Project	IEEE 802.16 Broadband Wireless Access Working Group < http://ieee802.org/16 >	
Title	Primitives Supporting Association Procedures	
Date Submitted	2007-01-12	
Source(s)	Ronald Mao	Voice: 858-882-0335 Fax: 858-882-0350 rmao@huawei.com
Re:	P80216g_D6	
Abstract	This contribution proposes C_SAP primitives to be adopted in IEEE 802.16g to support association procedures specified in IEEE 802.16e-2005.	
Purpose	Adopt the contribution.	
Notice	This document has been prepared to assist IEEE 802.16. It is offered as a basis for discussion and is not binding on the contributing individual(s) or organization(s). The material in this document is subject to change in form and content after further study. The contributor(s) reserve(s) the right to add, amend or withdraw material contained herein.	
Release	The contributor grants a free, irrevocable license to the IEEE to incorporate material contained in this contribution, and any modifications thereof, in the creation of an IEEE Standards publication; to copyright in the IEEE's name any IEEE Standards publication even though it may include portions of this contribution; and at the IEEE's sole discretion to permit others to reproduce in who

Figure 0-1 Primitives to report association ranging information

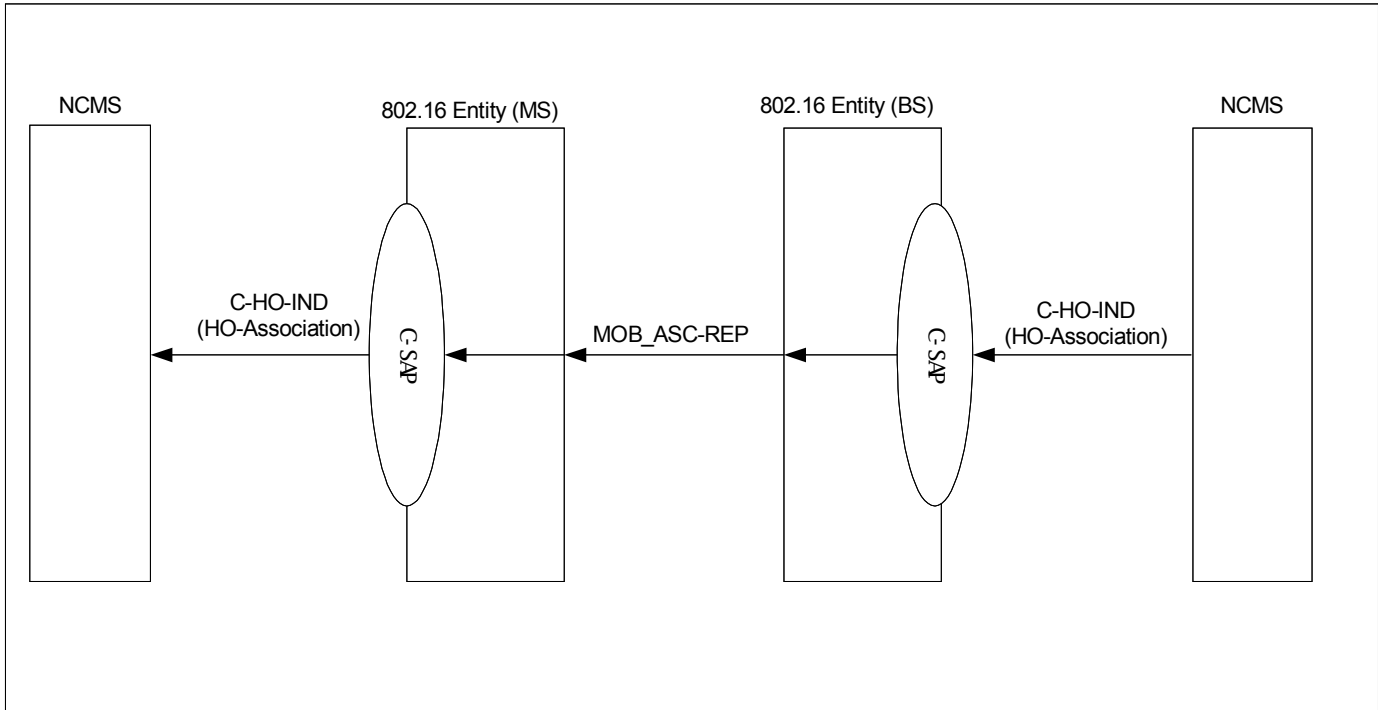
In order to perform association ranging effectively, the MS must know the ranging assignment from the neighboring BSs to avoid ranging collision. After ranging request, the resulting ranging parameters from the neighboring BSs can be delivered to the MS via the serving BS over the network backbone to save air interface bandwidth. Those objectives can be achieved by different levels of association.

The association parameters are delivered in the new primitive C-HO-IND (HO-Association). This is only applicable to Association Level 2. For Level 0 or 1, the parameters are delivered in RNG-RSP. The delivery of the parameters from the neighboring BSs to the serving BS is out of scope.

[Insert this diagram after Figure 493 on Page 78]
